**MONTGOMERY COUNTY HISTORIC PRESERVATION COMMISSION**  
**STAFF REPORT**

<b>Address:</b>	220 Park Ave., Takoma Park	<b>Meeting Date:</b>	10/24/18
<b>Resource:</b>	Contributing Resource <b>Takoma Park Historic District</b>	<b>Report Date:</b>	10/17/18
<b>Applicant:</b>	Rebecca and David Williamson	<b>Public Notice:</b>	10/10/18
<b>Review:</b>	HAWP	<b>Tax Credit:</b>	n/a
<b>Case Number:</b>	37/03-18QQQ	<b>Staff:</b>	Dan Bruechert
<b>Proposal:</b>	Chimney Removal

Detail: View from front of 220 Park Ave  
The small, second chimney is in the rear

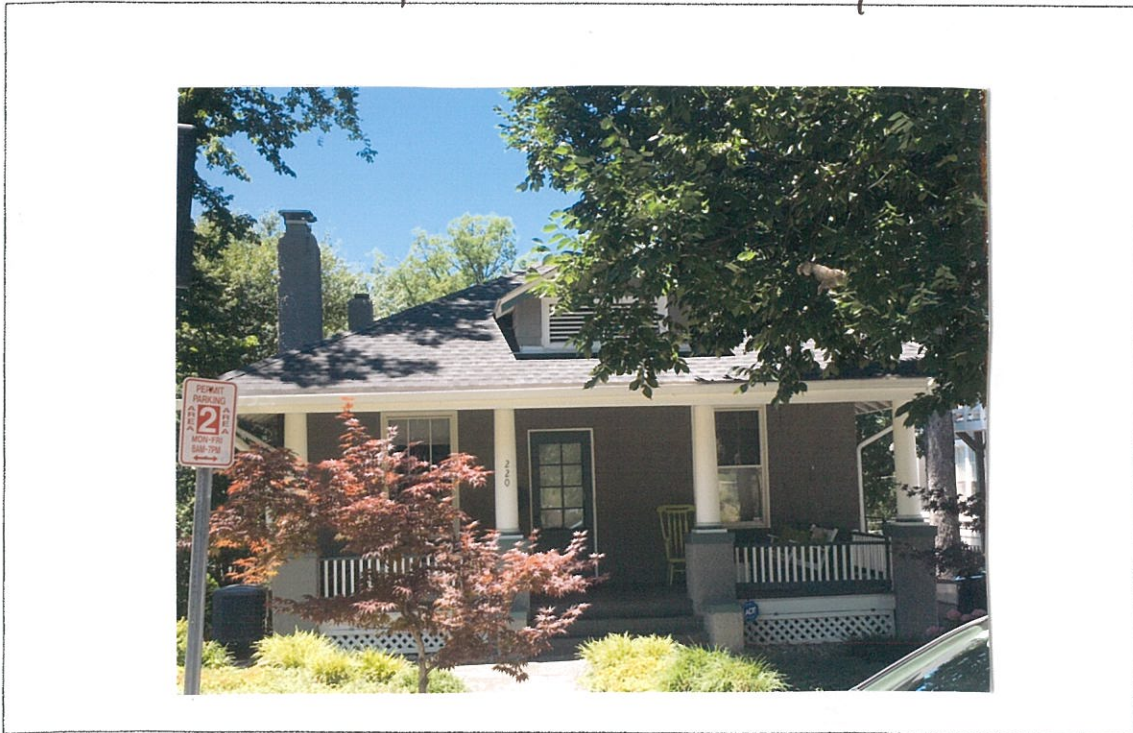
The house at 220 Park Ave. has two chimneys on the left elevation, a larger exterior chimney to the front and a smaller interior chimney to the rear. Both chimneys are covered in the same rough stucco and are visible from the public right-of-way. Internally, the chimney to the rear is not associated with a fireplace and the applicant suspects that the chimney was associated with a woodstove. Staff has been unable to determine if the rear of the house is an addition or original construction. Because most of the houses in the surrounding district only have one chimney, Staff reasons that there is a high likelihood that this rear chimney is a later, non-historic modification to the house.

Staff finds that the removal of the rear chimney will not have a significant impact on the visual and character of the house for several reasons. First, this chimney is partially obscured by the larger, front chimney on the same side of the house, and is therefore not a character defining feature of the house. Second, the rear chimney is set back from the street front to the extent that it's removal will have less impact on the building patterns in the surrounding district, per the *Guidelines*. Third, Staff finds that the removal of the rear chimney will not have a significant impact on the historic character of the house, per Standard 2, as the decorative elements (i.e. columns, full-width front porch, front gable dormer) will all remain expressed from the public right-of-way. Finally, consistent with Staff's reasoning that this feature is not historic, its removal is compatible with the architectural features of the house (see 24A-8(b)(2)).

Detail: close-up of our 2<sup>nd</sup> chimney

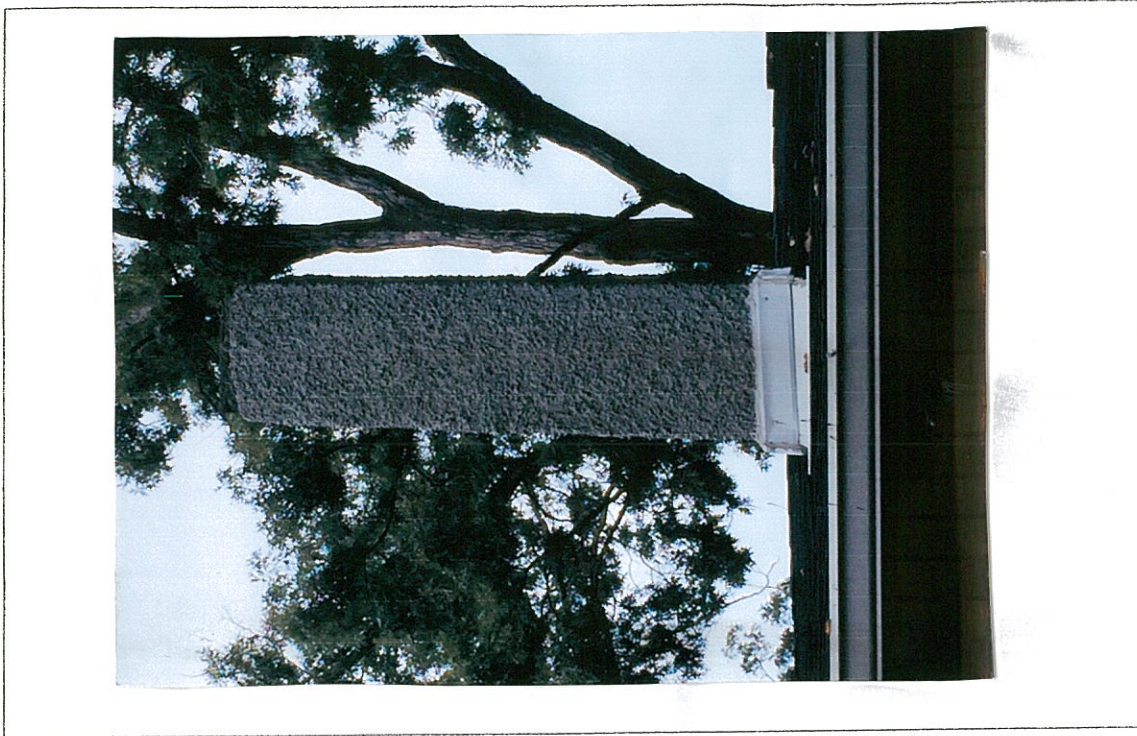
Detail: Close-up of unconnected + unused chimney in the walls of our house

Detail: 2nd, small chimney is rear of 220 Park Ave

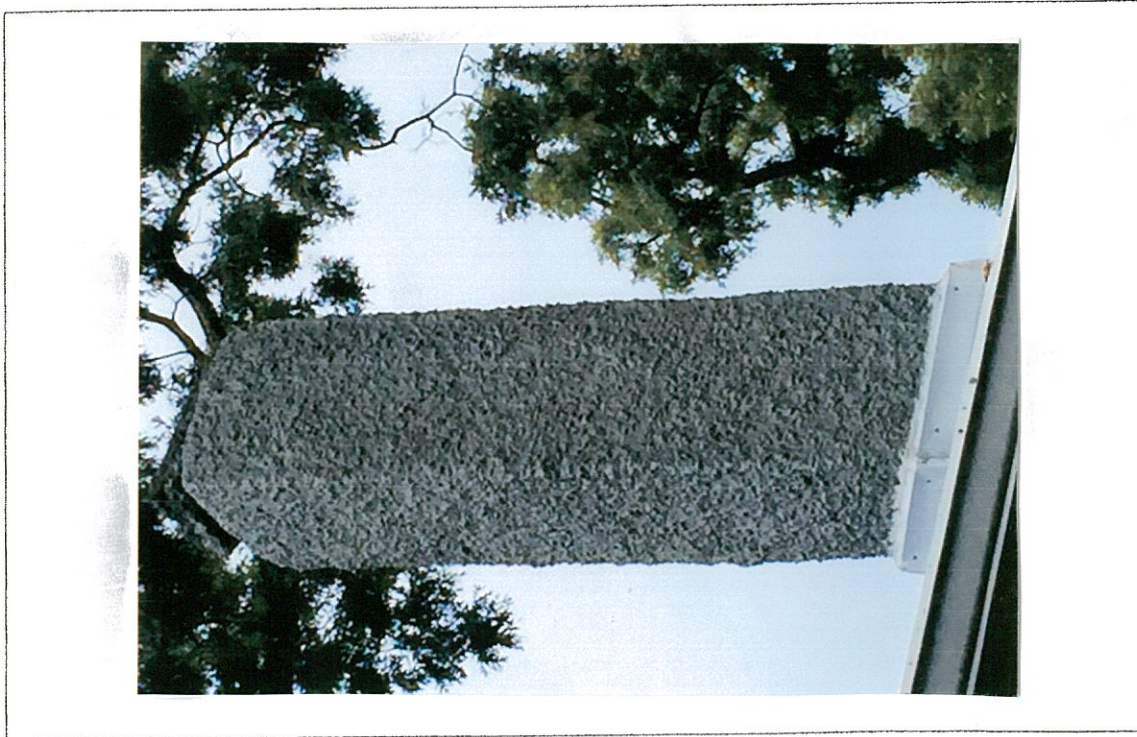
Detail: We'd like to remove our second, small chimney which is encased in the walls & remains unused.
